# Expert Report for the IPC Hearing for the Narrabri Gas Project (SSD\_6367) Outstanding biodiversity impact and offset issues

David C. Paull (MResSc, Dip Hum., UNE)

9 August 2020

**Figure 2: Indicative layout of gas field in the forest, showing anticipated extent of access tracks (from Santos EIS, Narrabri Gas Project, Chapter 6, Project Description).**

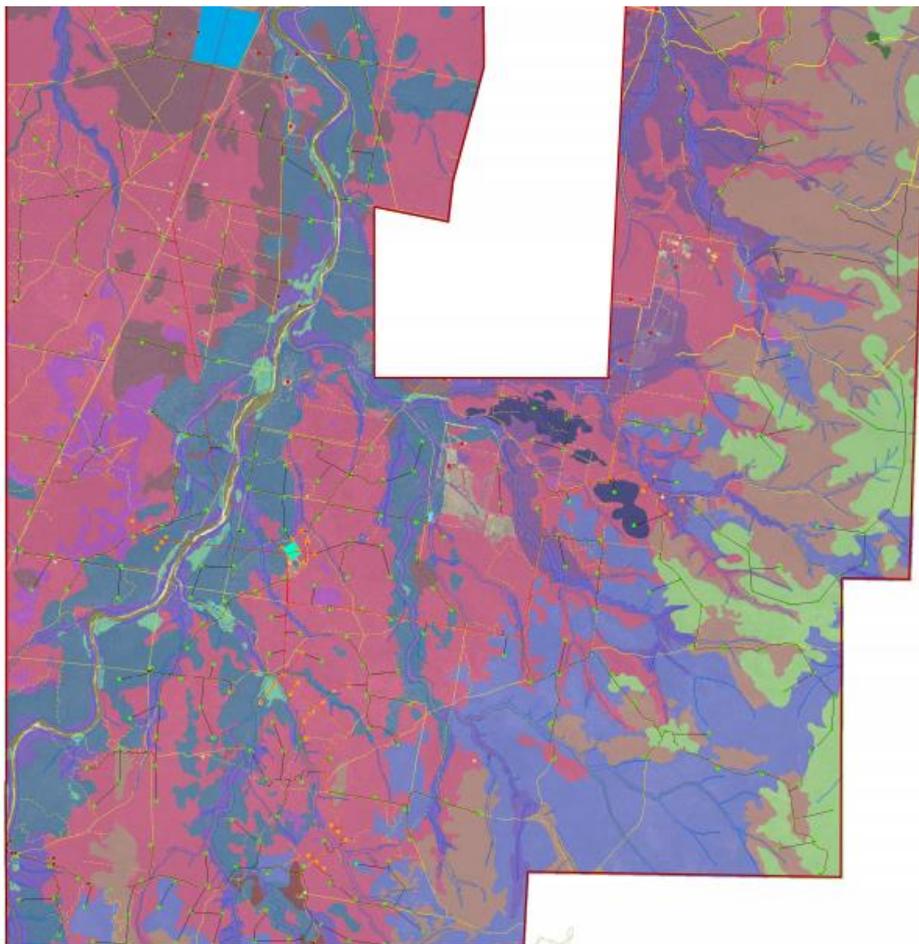
In the Project Description for the EIS, Santos presents an ‘indicative layout’ of the Narrabri field - (Figure 2). This figure also suggests the extent of new access roads will be a significant proportion of the total clearing within the forest itself, while not being as important outside the forest. Most new well sites in this figure are connected by new tracks, some lying parallel to existing roads.

The status of this indicative layout and how well it represents where an actual footprint may be expected is not clear and has not been clarified further by DPIE. It was not used to inform the biodiversity assessment for the Project, leading to further uncertainty regarding the direct impacts.

**Figure 6: Black-striped wallaby distribution in relation to the study area.**

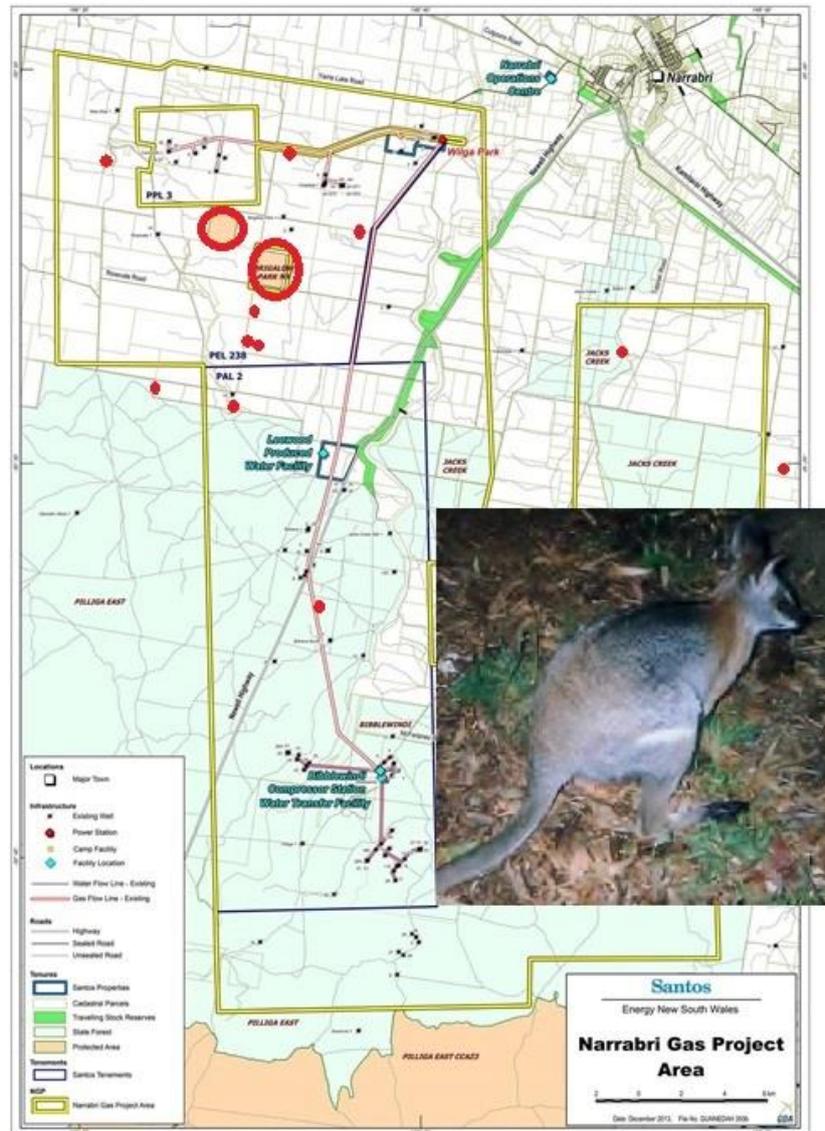
This population or about 90% of the population's known distribution lies within the Project Area. The Black-striped Wallaby is found in the north east part of the Pilliga Forest and among Brigalow remnants to the north of the forest. It maintains a line of dispersal from the Forest to the Brigalow remnants through the vegetated Bundock Creek which flows out of the forest into private lands to the north. Figure 6 show the two important remnants which are preferred habitat for this species, the Brigalow Park Nature Reserve and State Conservation Areas. Recommended Conditions of Consent state that Santos should erect a '50 m buffer' around both. What this means in terms of fencing around these two reserves remains unclear, as indeed, are fencing arrangements throughout the gasfield.

However, what these animals will experience will be an industrialisation of their home range. Their ability to leave and disperse from these two brigalow patches could be hampered by the increase of indirect impacts around gas wells and sites, fencing, increased traffic and the array of other indirect impacts on these animals.

Even though this species requires an offset for impacts of the development, this will be difficult to achieve as all parts of this population are likely to be affected by the Narrabri Gas Project. The status of this species in fire-ravaged areas in the NSW northern ranges is uncertain, increasing the importance of this isolated, western population.
